**From:** Ross Ullman <Ross.Ullman@sunshinecoast.qld.gov.au>  
**Sent:** Thursday, 23 February 2017 9:44 AM  
**To:** Steven Tarte; [Access refused under s6]@bmtwbm.com.au); James Ulyate  
**Cc:** Jaclyn McKirdy  
**Subject:** Potential Parallel Taxiway  
**Attachments:** SCA\_EIS\_Chapter A5 sand.jpg

Further to my comments at the last meeting in relation to the proposal by Palisade to consider construction of a parallel taxiway for approximately half the length of the new runway, I have reviewed the EIS and I have discovered that, whilst the parallel taxiway is not referred to specifically, the spread sand platform was always intended to cover the area that included the ultimate parallel taxiway alignment.

### **Issue 3 - Inconsistencies in maximum depth and dimensions of proposed drains**

Figure 2-1 Revised connectivity corridor at end of RWY13/31

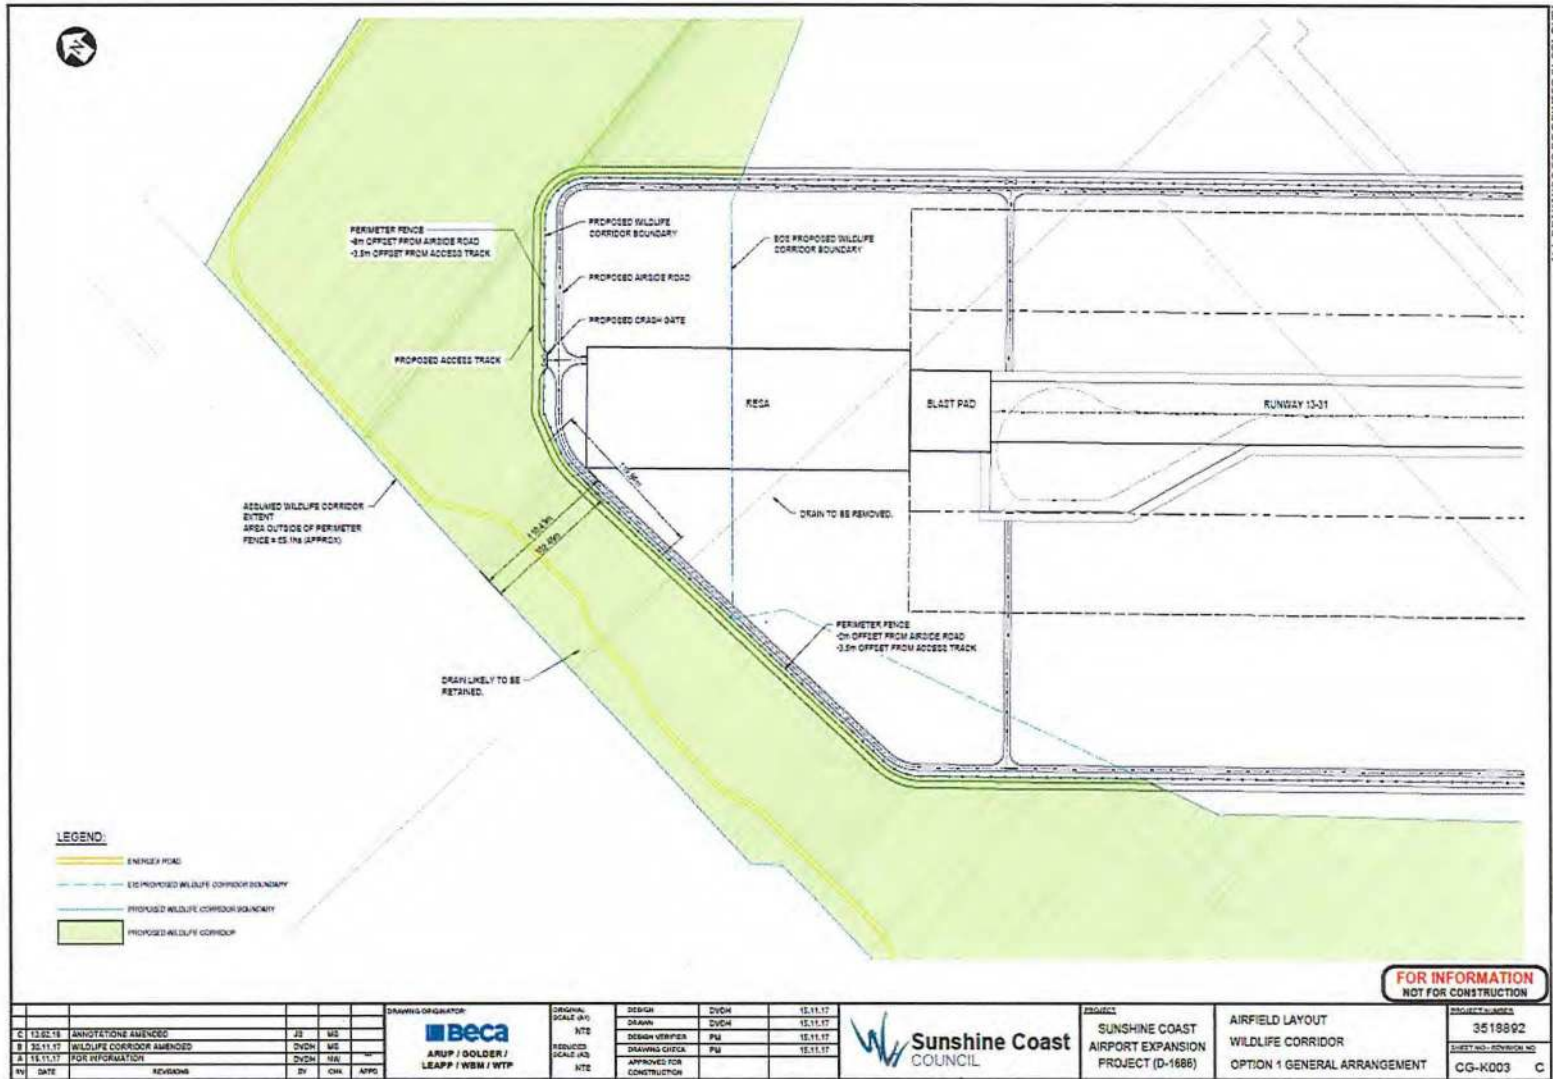
Movement of the end of the runway also marginally decreases the space available for the wildlife movement corridor. At the end of the runway it will be necessary to construct a fence and landside road for maintenance, as well as a potential swale drain feature. This will provide a corridor ~100 m fence-to-fence at its narrowest point for a 120 m continuous stretch. The ODP approved for the project will require amendment to account for the changed design. Regardless, the corridor will cover a minimum 42 ha (reduction from 48 ha in original proposal) and will provide the connectivity outcomes intended in the EIS. See Figure 2-1.

Figure 3-1 Location of dredge spoil containment area and other features in revised design

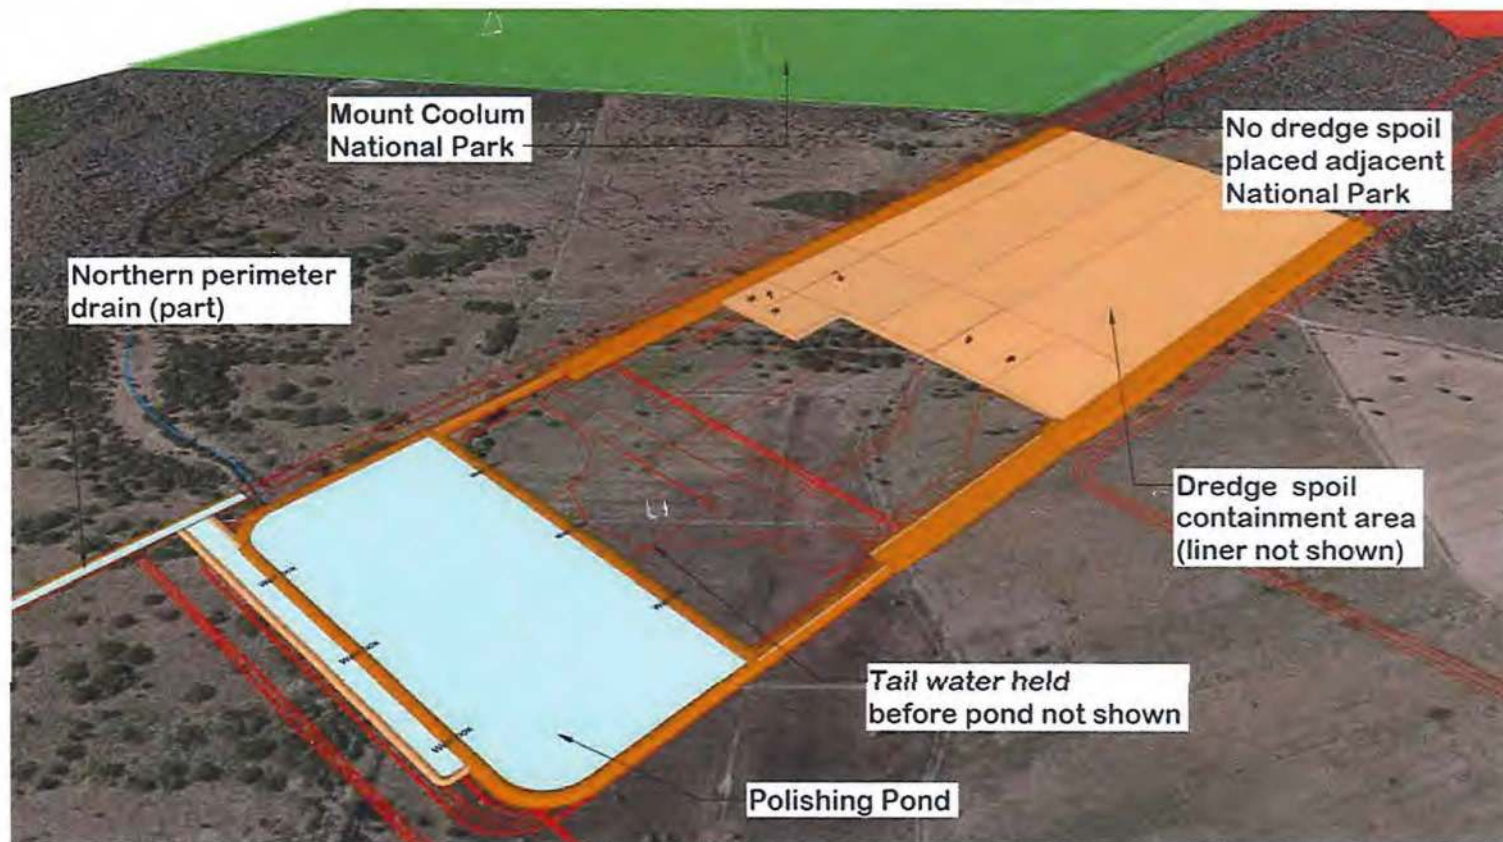
The proposed alternate methodology is to relocate the dredge spoil containment area to the northwest end of the reclamation area, over the full width of the works. From here material would be dewatered and then rehandled as 'dry' material back towards the southeast. Thus, dredge spoil containment and dewatering would occur in a smaller subset of the runway length rather than across the entire length. As a result, the HDPE liner would be placed only within the new spoil containment area rather than along the full length of the runway. The dredge spoil containment area would be split into two cells. At any point in time, one cell would be used for dewatering (directly receiving pumped sand) and the other as the source of material for rehandling.

The following figure shows the changes in design of this methodology. NOTE: This figure does not show the runway extension discussed in Section 2.

Figure 7.5 Revised HDPE Liner Area and Control Structures on Drains

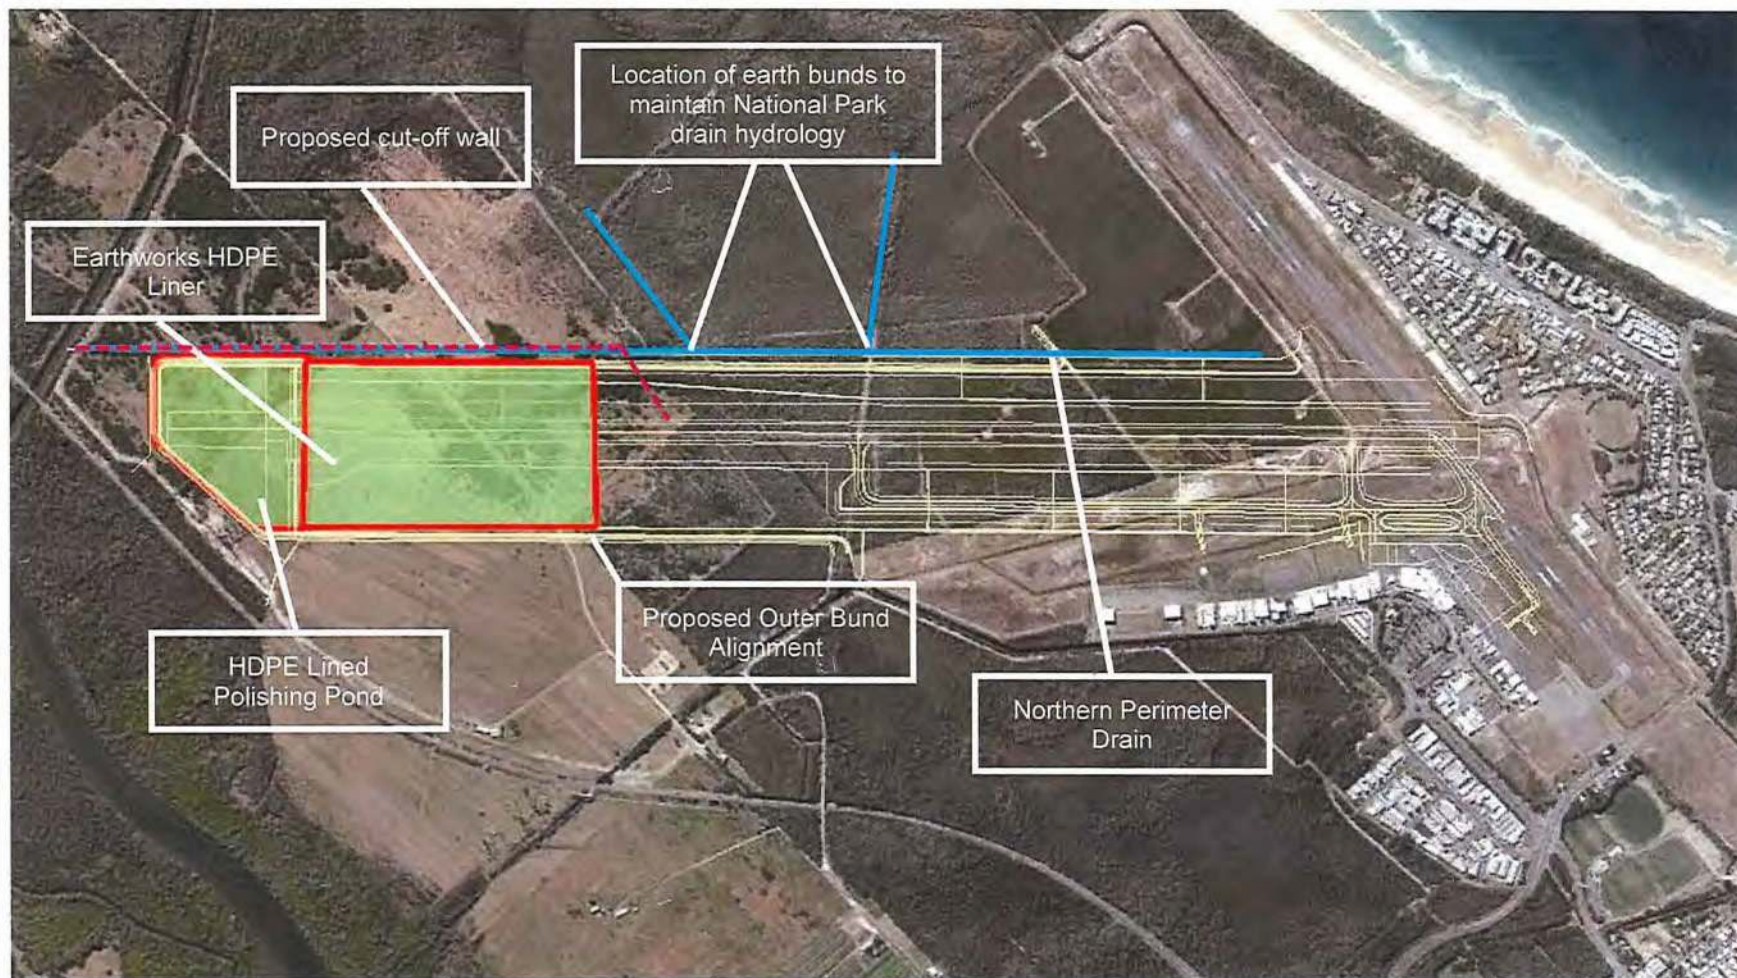
- 7.5 Extent of liner under dredge spoil containment area – changed to show new cut-off wall extent.

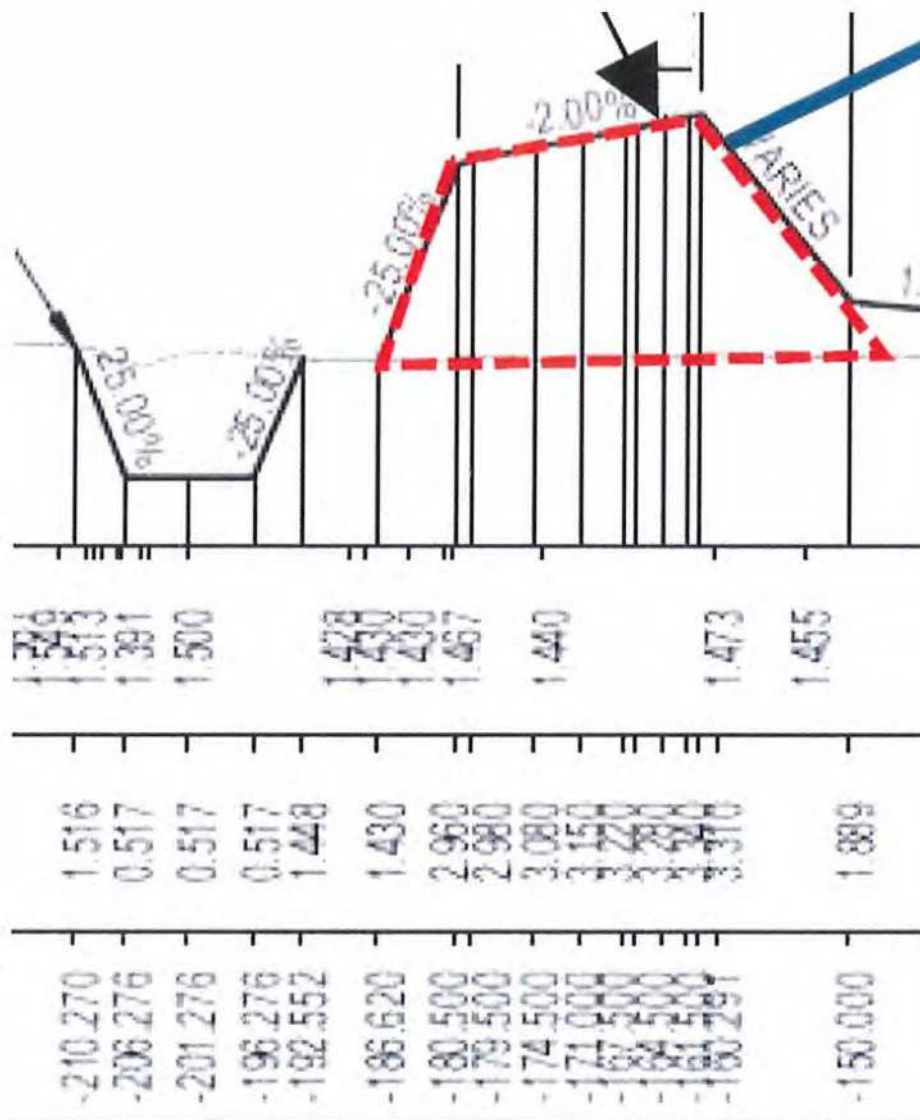
The amendment application advises that the geometry and depth of the northern and western perimeter drains have been revised to decrease their depth and width (see section 4 Modification of Drainage Approach). These include

However, the detailed cross sectional plan for the dredge spoil placement area shows construction of a 1 metre deep drain with a base width of 10 metres (see figure below).

1. Clarify the inconsistencies in maximum depth and dimensions of proposed drains in the EA amendment documentation.

2. Provide georeferenced plans illustrating drain locations and dimensions in plan and cross-sectional view.
3. Depending upon which drainage proposal is correct, propose environmental authority conditions for incorporation that reflect relevant limitations of drain depths and dimensions that form the basis for removing EIS approved mitigation measures.

Diagram 5 - Ground Elevation Contours and General Direction of Surface Water Flow (scale as shown)

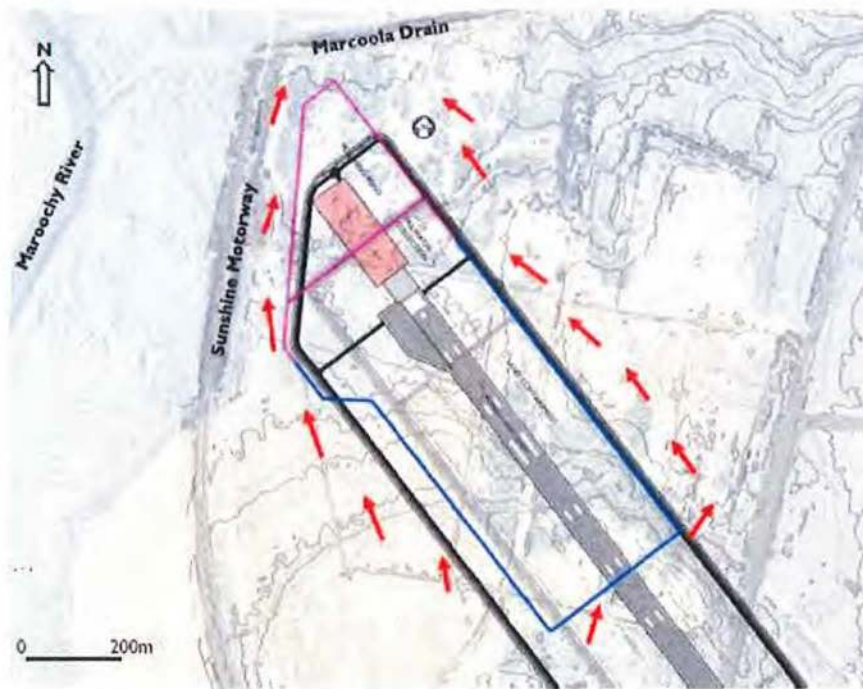
The hazard assessment for the dredged material containment area (including the tail water collection and polishing pond) considers that all surface water flows will be directed around the structures and into Marcoola drain (see diagram below). This contrast with drainage plans in the EIS (e.g. see appendix A4, Figure 4.1a) which showed surface flows also being directed into the southern perimeter drain.

Any flow of saline waste water or seepage into the southern perimeter drain would pose environment risks to the freshwater wetlands in the Mount Coolum National Park (south Marcoola section) and the Council Environmental Reserve.

Although the hazard assessment proposed removal and replacement of near surface soils in the event of an unplanned saline release, this is likely to be an ineffectual solution in this sandy environment with high groundwater table.

1. Clarify the likely fate of any inadvertent saline release from seepage, overtopping or failure of the dredged material containment area, including drainage arrangements and potential environmental impacts including on:

- a. the freshwater wetlands in Mount Coolum National park (south Marcoola section); and
  - b. the Council's adjacent environmental reserve (section of Coolum Creek and Lower Maroochy River Wetlands); and
  - c. environmentally significant areas under the biodiversity offset delivery plan.
2. Clarify apparent inconsistencies in drainage arrangements between the EA amendment application documents and the EIS.

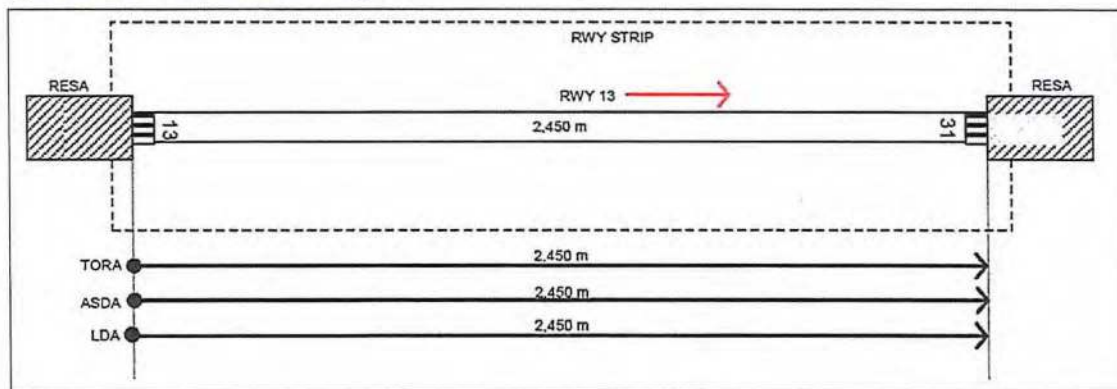
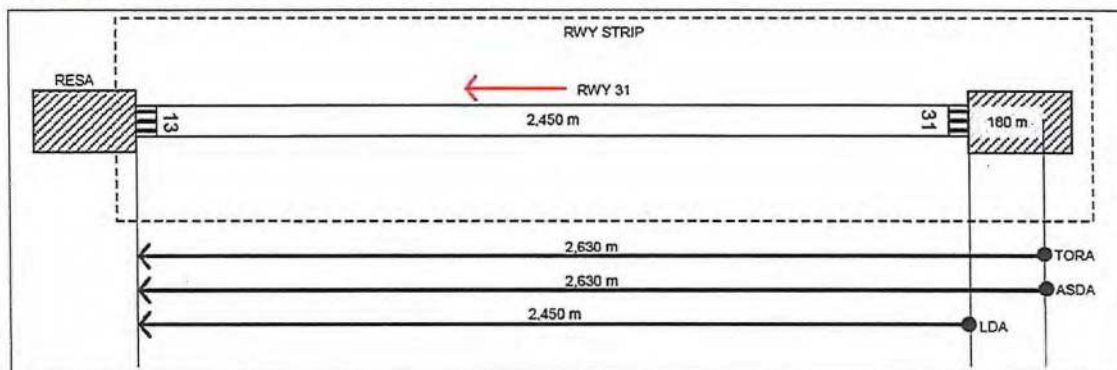
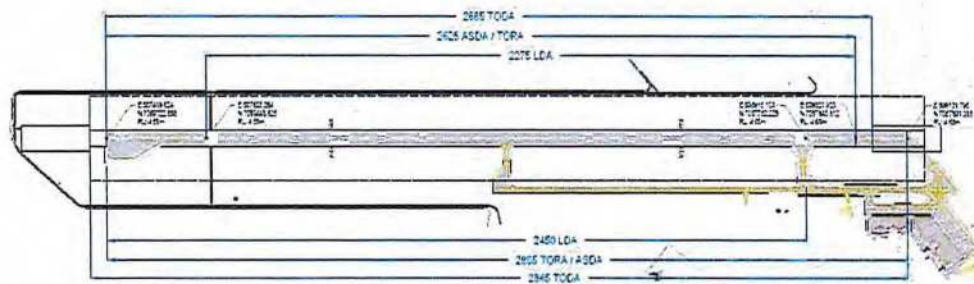
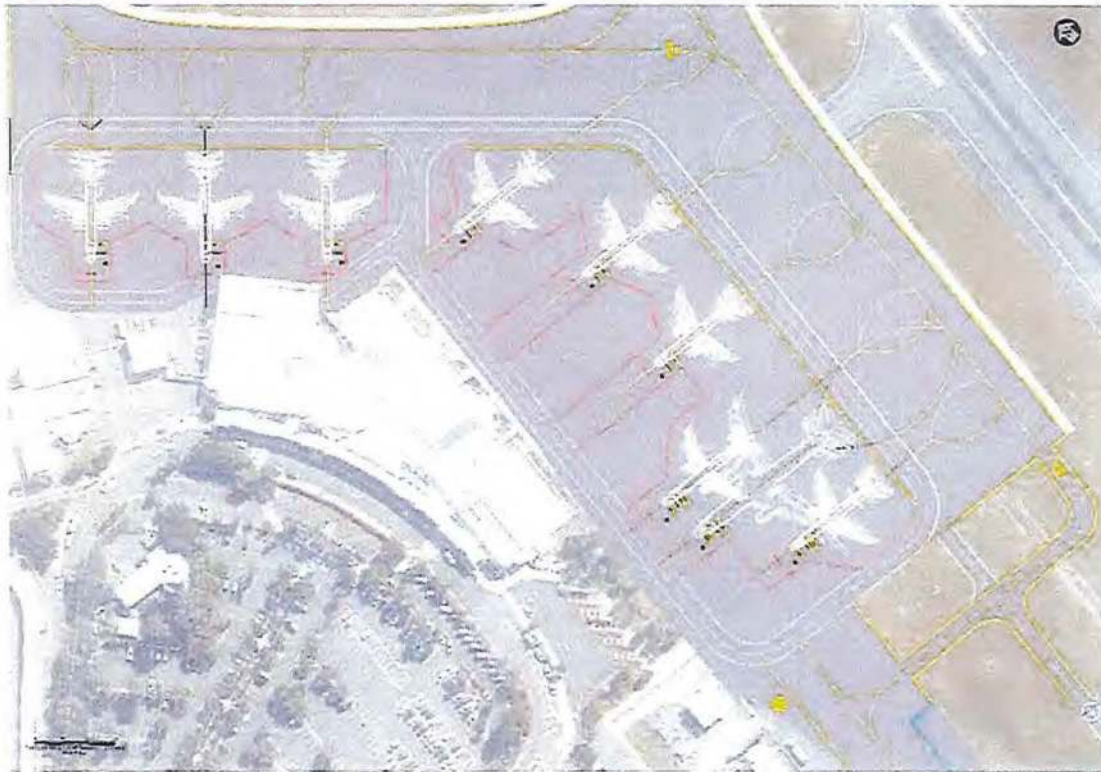
EIS	IFC	Rationale for Change
1.	Taxiway end loops at each end of the new runway. (Refer Fig 1)	Provision of turning node on NW end and parallel taxiway to midpoint of runway in lieu of end taxiway loops. (Refer Fig 2)	Reduced impact on flood plain, greater efficiency for airport operations. Sand volume impact neutral. Impact on noise by GA
